JONES & LAUGHLIN STEEL CORPORATION

Gentlemen: RE: CONTROL NO. 85823

In reference to our telephone conversation of February 23, 1977, the following additional information is forwarded for your consideration in reviewing our Byproduct License Application dated 1-21-77, for the Pittsburgh Works facility:

PITTSBURGH WORKS
 BY PRODUCT PLANT
 COAL HANDLING
 42" BELT CONV. "C"
 BULK DENSITY CONTROL

SKETCH

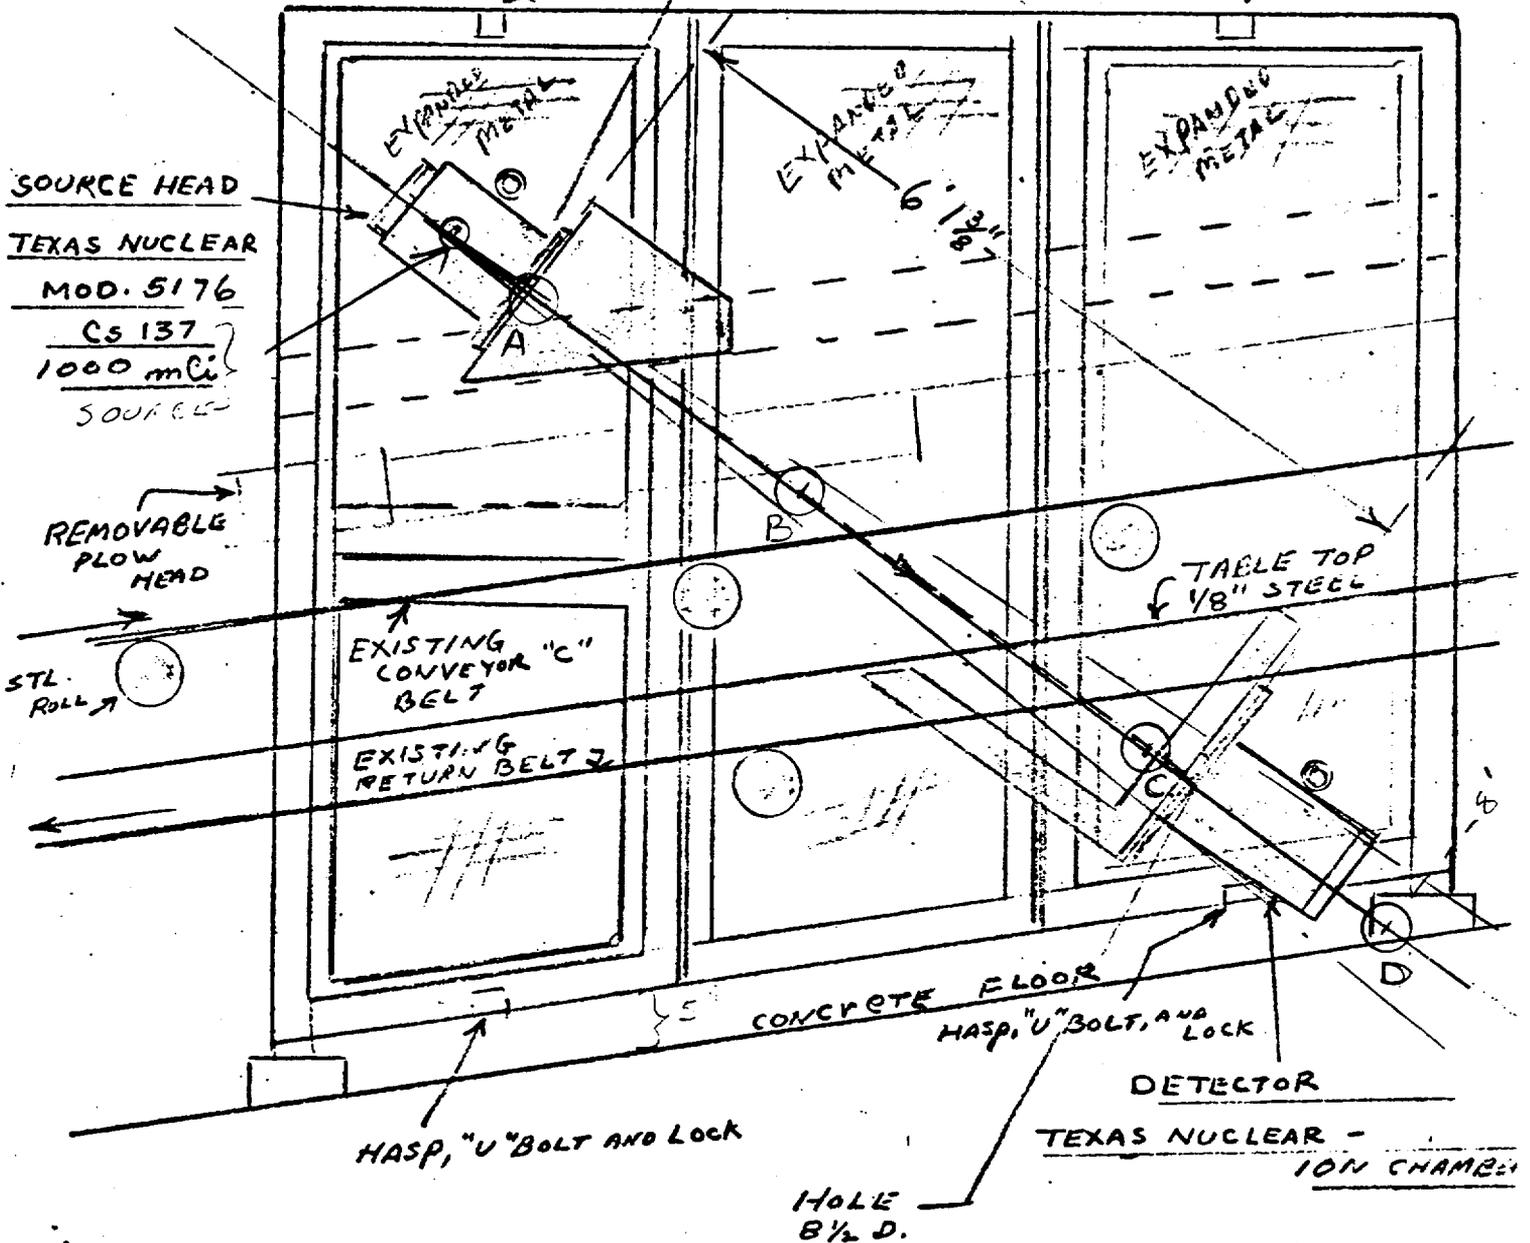
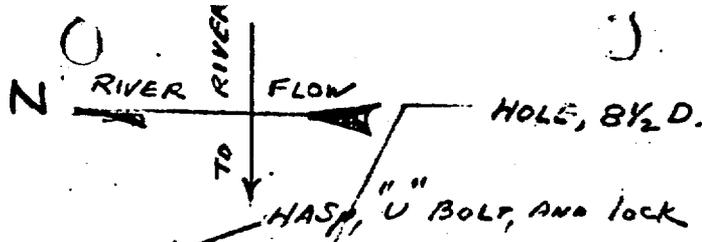
In reference to the area of 10-15 mr/hr referred to in this paragraph, please be advised that this area will be inside the locked expanded metal enclosure, behind the detector housing, when no product (coal) is on the conveyor belt. During normal operations, when coal is on the belt, this radiation level will be less due to further attenuation by the product.

This aforementioned area is at a distance of 8 feet from the source, in the attenuated primary beam, which will have a diameter of 9 inches at this point. The locked expanded metal cage enclosure has an outside diameter of approximately 5½ feet, and the air gap under this enclosure is approximately 5". (See Drawing PF-4935). Therefore, personnel whole body exposure is not physically possible.

Considering the "extremely remote" possibility of a workman lying on the concrete floor, with his shoulder directly against the side of the enclosure, with a normal arm length of 28 inches, the "tip" of his fingers would still be outside the primary beam (10-15 mr/hr). There is no need for a workman to assume this position at any time.

A "corrected copy" of the previously submitted "sketch" is enclosed as further illustration.
